**UNITED STATES
NUCLEAR REGULATORY COMMISSION**
REGION IV
1600 E LAMAR BLVD
ARLINGTON, TX 76011-4511

EA-14-228

**SUBJECT: WATERFORD STEAM ELECTRIC STATION, UNIT 3 – NRC COMPONENT
DESIGN BASES INSPECTION REPORT 05000382/2014007 AND PRELIMINARY
GREATER THAN GREEN FINDING**

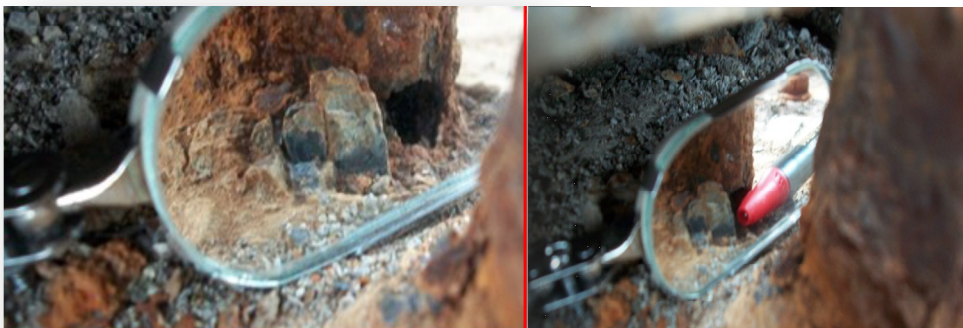
Both the train A and B vents were located on the roof of the same structure. The roof has a berm along the top of the perimeter. The photo on the right captures the scupper enclosure. All of the roof water would drain through this single drainage point. A piece of foreign material was also found on the roof. This material could block a portion of the scupper.

The above photos capture the thru-wall holes at the base of each 1 inch diameter vent pipe, where they exit the roof. A head-on view of the West vent hole is provided in the two pictures below. The East hole is not shown and was reported by the team as being the larger hole. An ink pen is shown in the right picture for perspective.

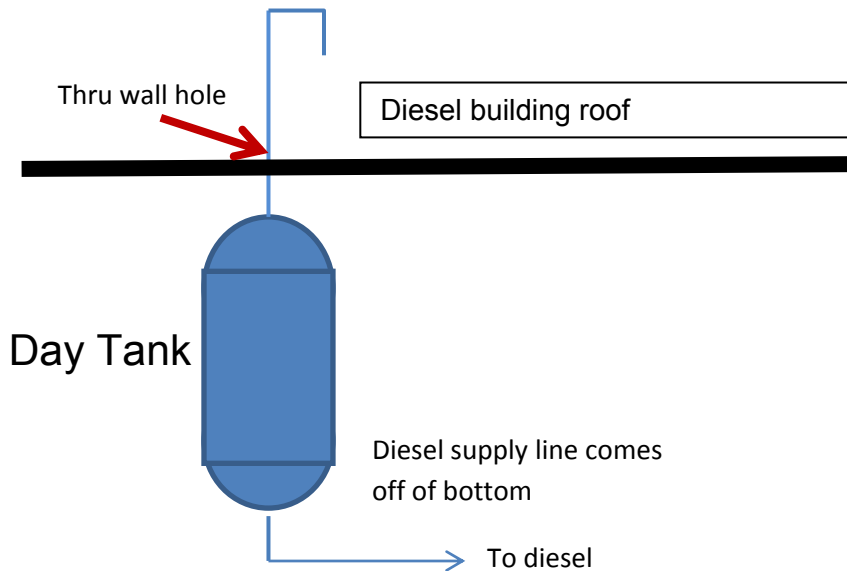
- The simplified drawing below is typical of both day tank configurations. The vents protrude through the diesel generator building roof and into the same drainage area.

- During a heavy rainfall event, water entering the through-wall vent holes would fall into the day tank. Since water is heavier than oil, the water would proceed to the bottom of the day tank. The fuel oil supply lines were attached to the very bottom of the tanks. Consequently, water that entered the tanks would transit directly to the supply lines and to the diesels. Both diesel generators were vulnerable to this problem.
